Office Action Summary

10/549,501

UYTTERHAEGHE ET AL.

DETAILED ACTION

Figure 2 (Uematsu)

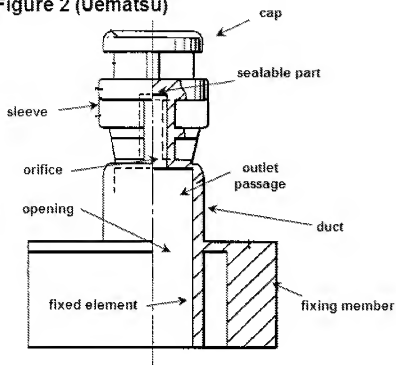
4. Regarding Claim 1, Uematsu discloses a closure device 20 (Figure 2) intended to be mounted on an opening (Figure 2 below) of a fluid product reservoir, said device being formed as a single piece by injection molding (Column 1, Line 56) plastic material (Column 4, Line 12) and comprising a fixing member (Figure 2 below) intended to cooperate with the reservoir opening to form a sealed attachment, a dispensing duct (Figure 2 below) forming an outlet passage (Figure 2 below) for the fluid product contained in the reservoir, said duct forming a dispensing orifice (Figure 2 below), a closing member 20 (Figure 2) to close and seal said duct, said closing member being joined to the dispensing duct by at least one bridge of material 28 (Figure 10A) intended to be broken when the closing member is first removed, characterized in that said closing member comprises a sealable part (Figure 2 below); said sealable part, before sealing, leaving the dispensing orifice clear and, after sealing, closing the dispensing orifice in sealed manner.

5. Regarding Claim 2, Uematsu discloses a closing member 20 (Figure 2), dispensing duct (Figure 2 above), and at least one bridge of material 28 (Figure 10A) are formed as a single piece (Figure 2).
6. Regarding Claim 3, Uematsu discloses a sealable part (Figure 2 above) which is deformable and can be welded to itself (Figure 2).
7. Regarding Claim 4, Uematsu discloses a sealable part (Figure 2 above) which comprises a fixed element (Figure 2 above), connected to the duct by at least one bridge of material 28 (Figure 10A), and a sealing cap (Figure 2 above) intended to be fixed irremovably on the fixed element, said cap closing and sealing the dispensing orifice.

8. Regarding Claim 5, Uematsu discloses a cap (Figure 2 above) which is connected, articulated fashion, to the fixed element (Figure 2).
9. Regarding Claim 6, Uematsu discloses a cap (Figure 2 above) and a fixed element (Figure 2 above) which are formed as a single piece.

10. Regarding Claim 7, Uematsu discloses a cap (Figure 2 above) which is welded onto the fixed element (Figure 2).
11. Regarding Claim 8, Uematsu discloses a cap (Figure 2 above) which forms a sealing bush (Figure 2 above) intended to come into sealed contact with the duct for its sealed closing.

13. Regarding Claim 10, Uematsu discloses a closing member 20 (Figure 2) which comprises a peripheral sleeve (Figure 2 above) connected at one end to the outside of the duct by said at least one bridge of material 28 (Figure 10A), said sleeve comprising as opposite peripheral end forming the sealable part.

14. Regarding Claim 11, Uematsu discloses a duct (Figure 2 above) and a closing member 20 (Figure 2) which are provided with snap-fit means 29 (Figure 10A) intended to cooperate after the breaking of said at least one bridge of material.
